Proposed: Downer bungalow + Septic Tank

Proposed dormer bungalow and septic tank at Glassamucky, Tallaght for S. Anderson.

Report of the Dublin Planning Officer, dated 16 September 1991

Report of the Dublin Planning Officer, dated 10th June, 1991.

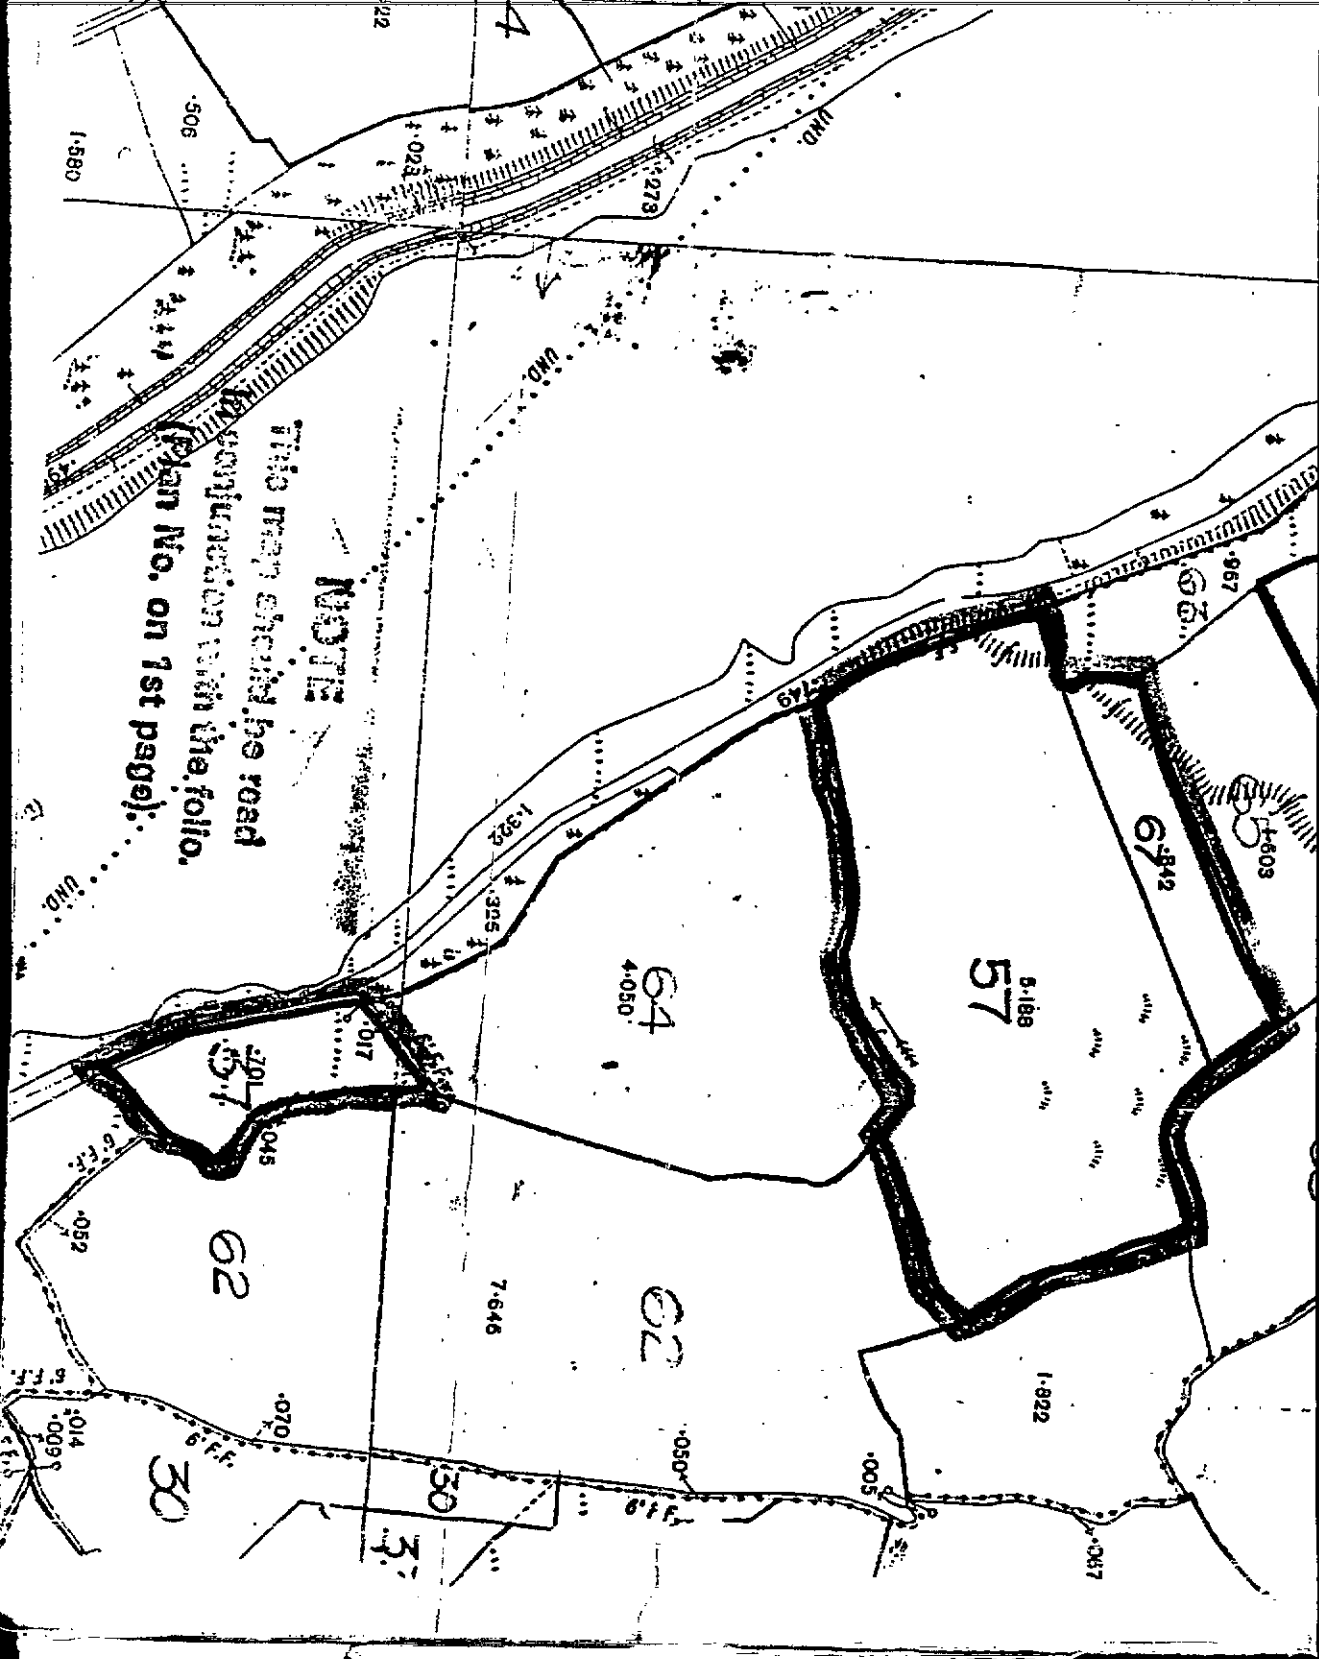
2. The applicant is requested to submit a map showing the extent of the applicants' family landholding and to indicate if in the event of a decision to grant permission being considered, the applicant and/or his family would be willing to enter into an agreement under Section 38 of the Local Government (Planning and Development) Act 1963, sterilising the remainder of this landholding from any future development. *The family dwelling should also be shown on a location map.*

- 1) Enclosed is a map showing the applicants family
land holding out lined in Red. and also location of
the family dwelling House marked on the map.
- 2) I have been instructed by my client that his family
are willing to enter into an agreement under Section
38 of the Local Government (Planning and Development)
Acts, 1963, sterilising the remainder of the land holding
from any future development:

BLOCK PLAN Scale: 1:500

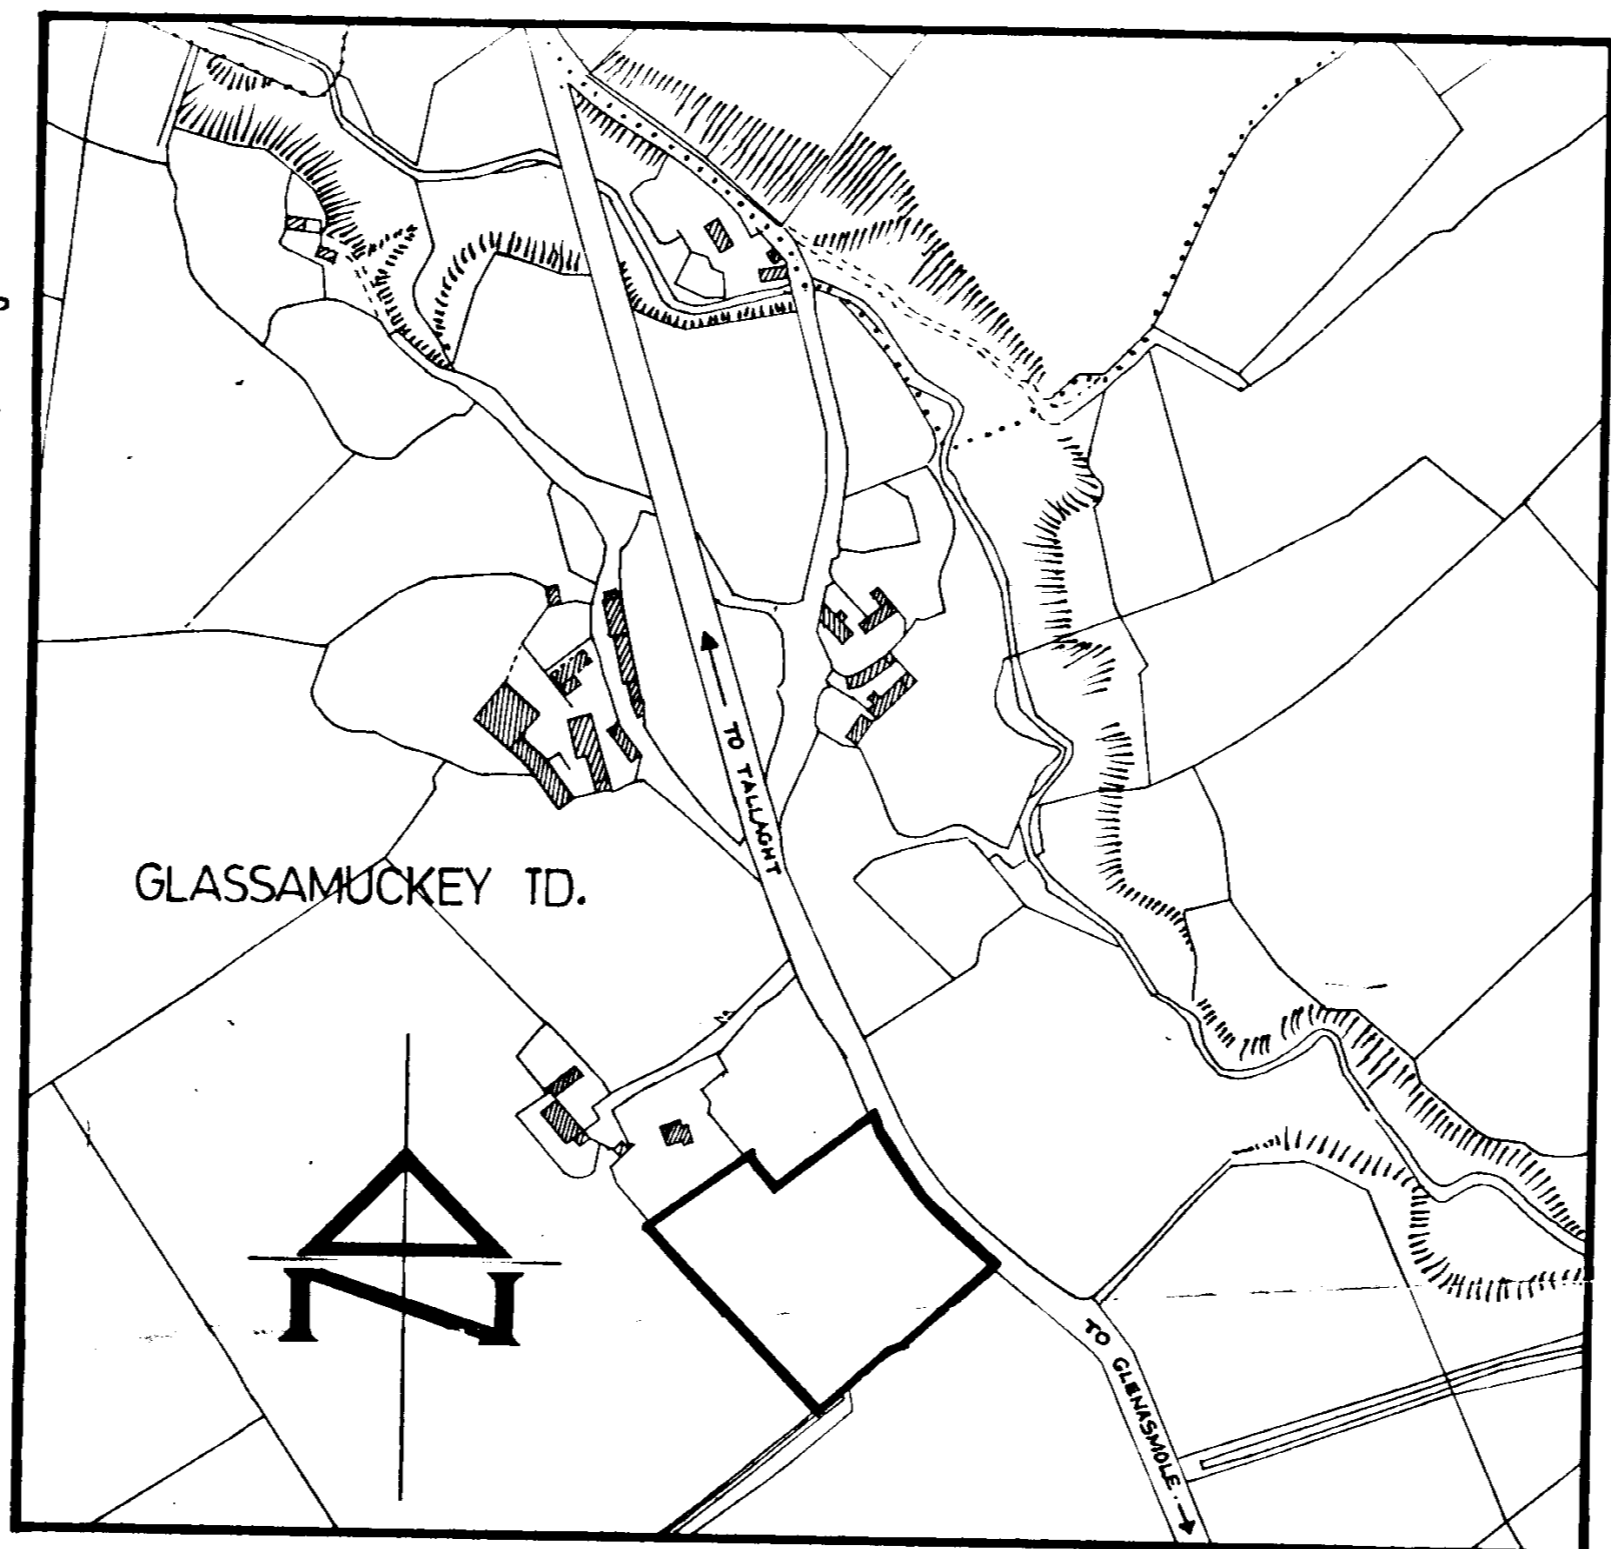
5. The applicant is requested to show on the block plan of the site, ground levels at 5 metre intervals across the site.
6. The applicant is requested to state the proposed finished floor levels of the house.

- 1) Revised House Design single storey with Low Pitch Roof.
- 2) a map is being Required for Land Reg. Dept. to show all the land in the family Landholding.
- 3) We have been in contact with Dublin Corporation waterworks Section & the Proposed House is not within the catchment area of the Bohernabreena Reservoirs.
- 4) A Trial Hole has been opened & inspected by officers from the Environmental Health Section.
- 5) items 5 & 6 are shown on Revised site plan.
